ERRATA #3 TO THE FINAL EIR

The City of Los Angeles (City) has prepared this Errata to provide clarifications to the proposed 6433 La Tuna Canyon Road Project (the Project). Specifically, this document comprises the third Errata to the Final Environmental Impact Report (Final EIR) and constitutes part of the Final EIR that will be considered by the decision-makers prior to approving, approving with conditions, or disapproving the Project.

Subject: **UDPATED TRAFFIC ANALYSIS FOR THE PROPOSED VERDUGO HILLS RESIDENTIAL PROJECT AT 6433 LA TUNA CANYON ROAD (CPC-2007-3082-VZC-SPR-SPP)**

Subject: **Response to Comments Raised at November 28, 2018 Deputy
Advisory Agency/Hearing Officer Hearing
CPC-2007-3082-VZC-SPR-SPP
VTT-69976-SL
6433 La Tuna Canyon Road**

FIGURE 7-2 (REVISED) PROJECT TRAFFIC VOLUMES

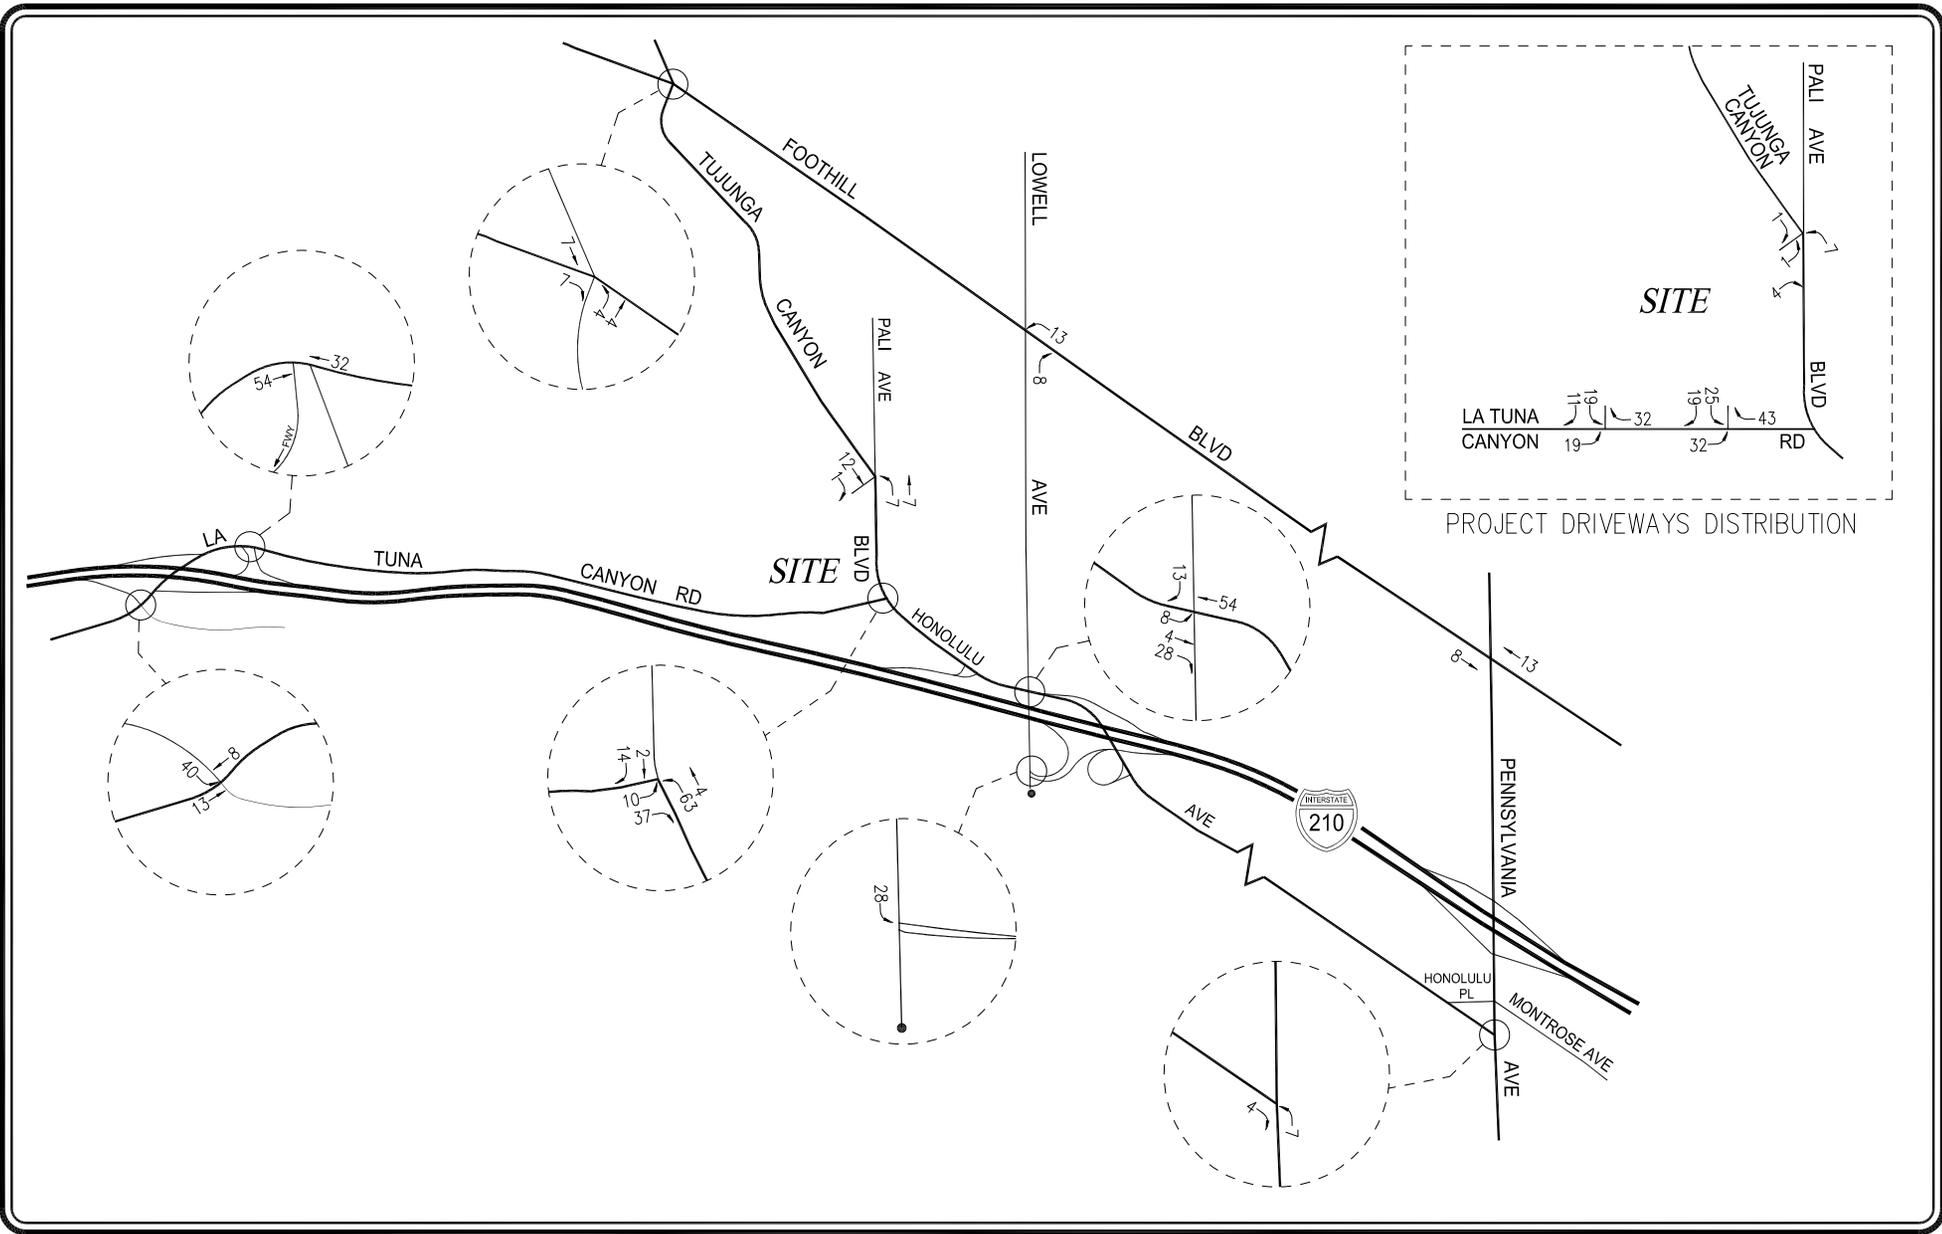
- The forecast net new weekday AM and PM peak hour Project traffic volumes at the study intersections associated with the Alternative 6(a) development are presented in revised Figures 7-2 and 7-3, respectively. The existing with Project traffic volumes at the study intersections during the weekday AM and PM peak hours are illustrated in revised Figures 9-1 and 9-2, respectively. The future cumulative baseline (existing, ambient growth and related projects) traffic volumes at the study intersections during the weekday AM and PM peak hours are presented in revised Figures 9-3 and 9-4, respectively. The future cumulative with Project traffic volumes at the study intersections during the weekday AM and PM peak hours are illustrated in the revised Figures 9-5 and 9-6, respectively.

FIGURE 9-9 YEAR 2021 FUTURE CUMULATIVE WITH PROJECT TRAFFIC VOLUMES

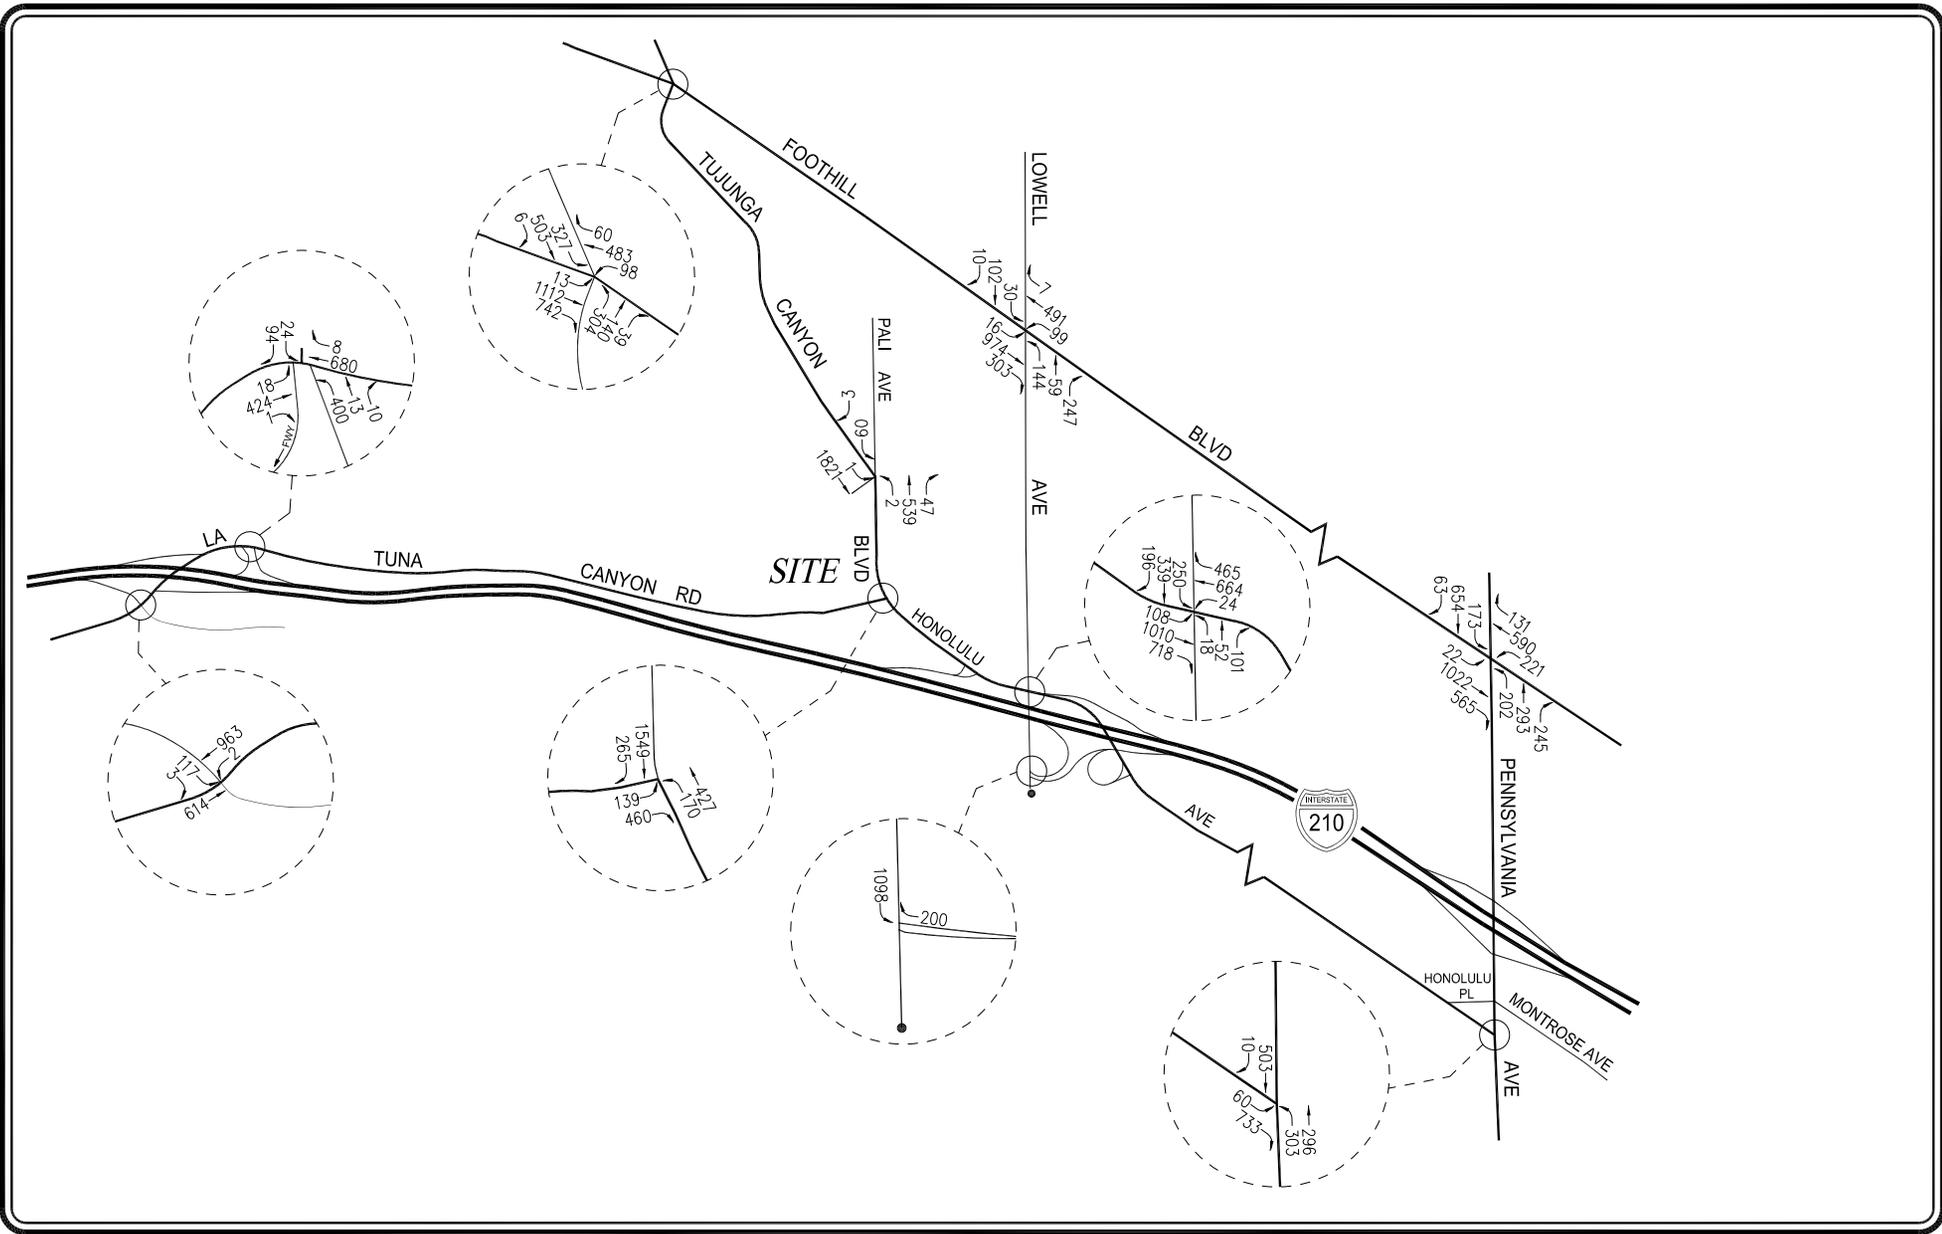
- The year 2021 future cumulative baseline (existing, ambient growth and related projects) traffic volumes at the study intersections during the weekday AM and PM peak hours are presented in Figures 9–7 and 9–8, respectively. The year 2021 future cumulative with Project traffic volumes at the study intersections during the weekday AM and PM peak hours are illustrated in the Figures 9–9 and 9–10, respectively.
